REMARKS

In the Office Action of September 1, 2004, the Examiner (1) objected to the drawings, (2) objected to the specification and (3) rejected claims 1-3, 7-11, 14, 15 and 19-21, which are all of the pending claims. Applicant will respond to the issues presented in the Office Action, in the order in which they were raised.

Docket No.: T0461.70003 US00
Date: December 22, 2004
x01/01/05

Fig. 6A

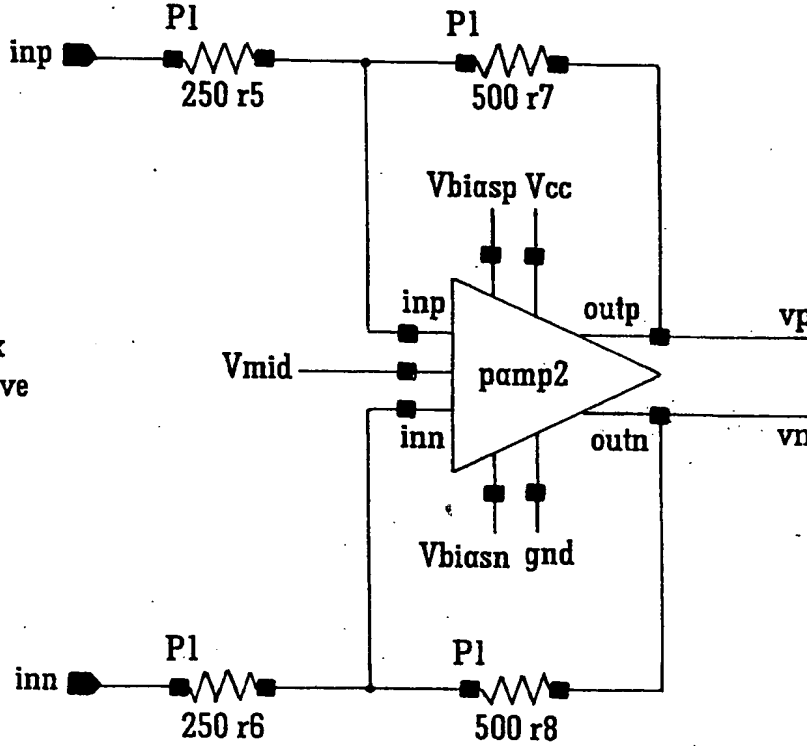
Figs. 6A and 8 are amended to conform their output terminal and signal labels.

To expand somewhat, if the voltage vp is higher than the voltage Vmid, then resistor r7 (Fig. 6A) pulls up on the input inp and turns off transistor mn1, allowing transistor mp6 to pull up on the gate of transistor mp2. This turns off transistor mp2, allowing transistor mn2 to pull down on the terminal vp. This negative feedback stops when the voltage on terminal vp equals vmid. A mirror image operation occurs with respect to the voltage on terminal vn.

Applicant has also amended Figs. 6A and 8 to make consistent the labeling of outputs of Pamp 4. Copies of those figures marked in red and labeled "Annotated Sheet Showing Changes" are attached, along with Replacement Sheets for Figs. 1-8 and a new sheet for Fig. 9.

Fig. 8

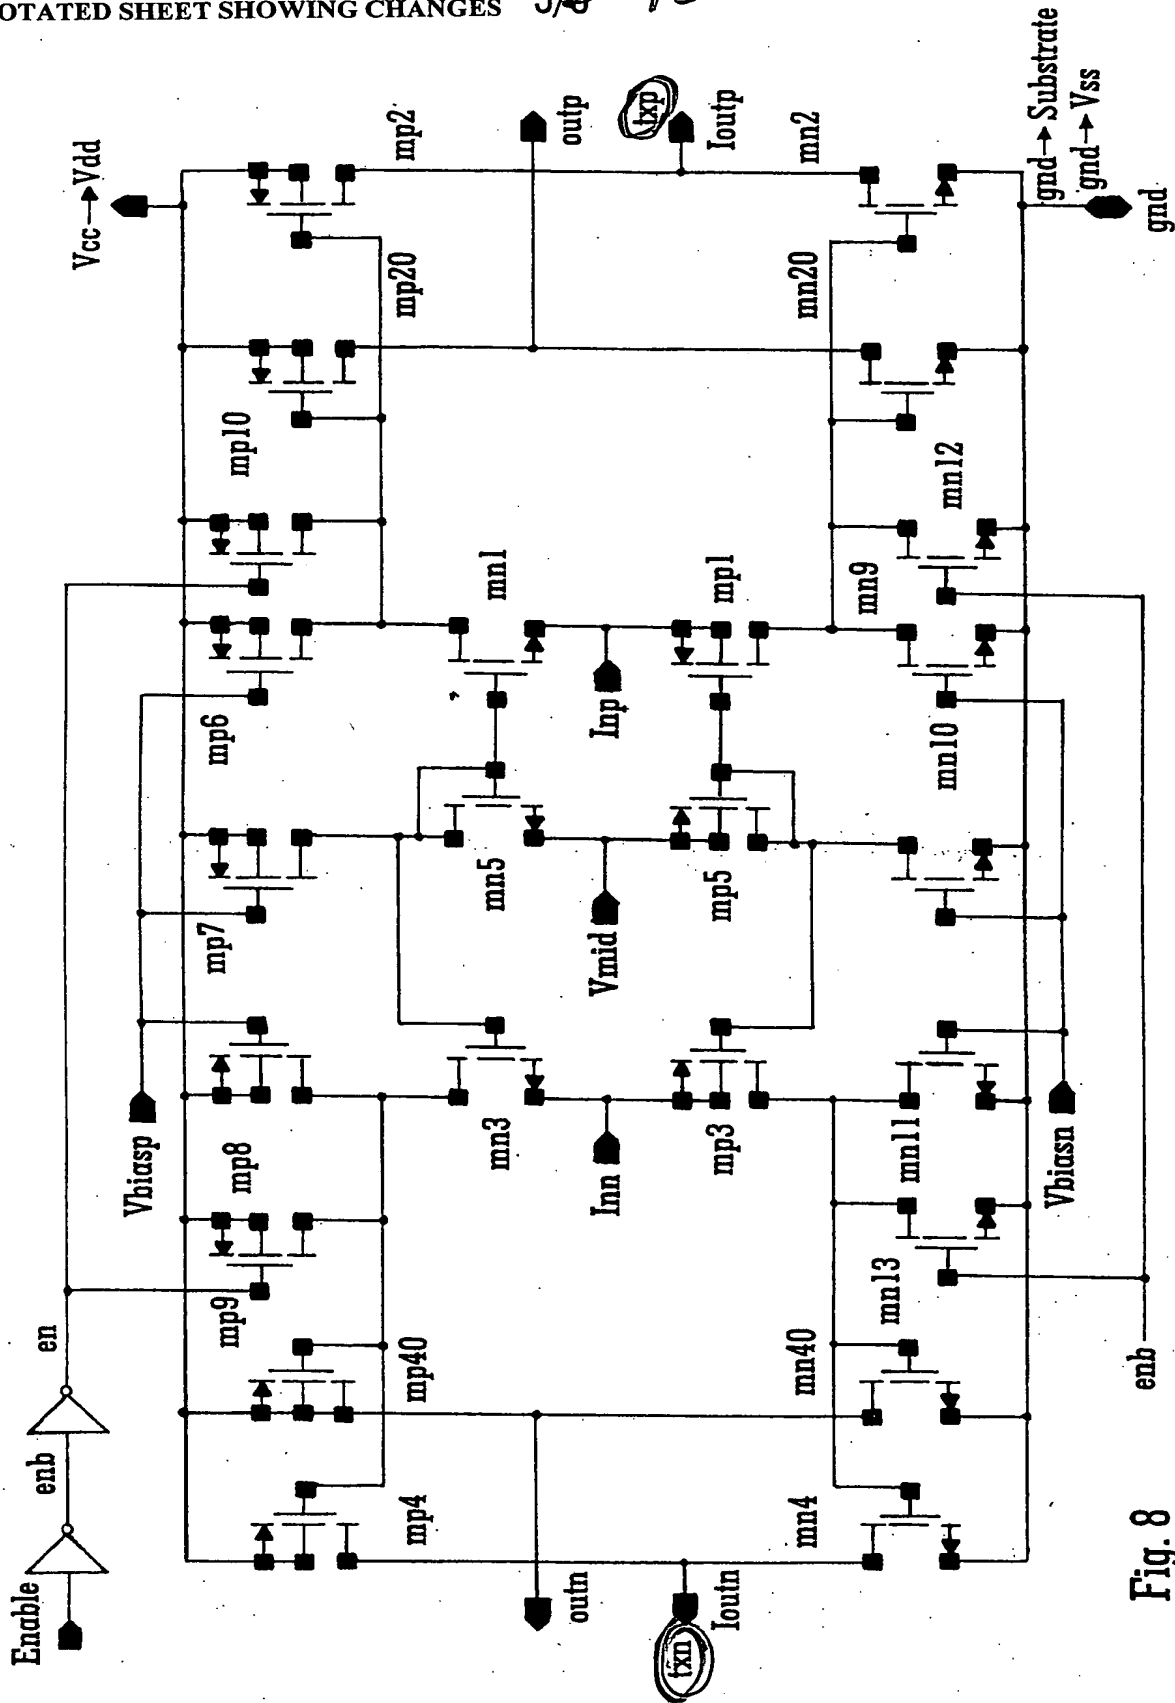
The Examiner had objected to Figs. 5, 6, and 8 because the reference designators are not readable. However, on August 12, 2004, seven sheets of formal drawings were filed. It would appear that they were not in the file when the Examiner acted upon the application. The formal drawings should resolve the objection.

With reference to pages 13 and 14, we note first the statement on page 14, in the paragraph spanning lines 6 -11, that the switched current feedback amplifier Pamp4 of Fig. 6 (further illustrated in the example circuit of Fig. 8) is similar to the Fig. 7 amplifier. We further refer to the discussion of Fig. 7 amplifier Pamp2 on page 13. There, it is explained from lines 24-35 how vmid couples to the termination elements. Indeed, the relationship between the voltage on the input terminals and vmid determines whether current flows in the input terminals. If so, this signal current is converted to a voltage gain which drives the current at outp flowing from vcc to outp. Or, with the reverse polarity, when the input Inp is below vmid, then the current flowing in transistor mp1 is the current Imn9 minus the signal current. After signal current is converted to a voltage gain, that voltage drives the output device to reduce the current flowing from outp to ground. The mid-point termination voltage is thereby coupled to the termination elements which receive the output. The coupling is fully shown in Figs. 7 and 8.
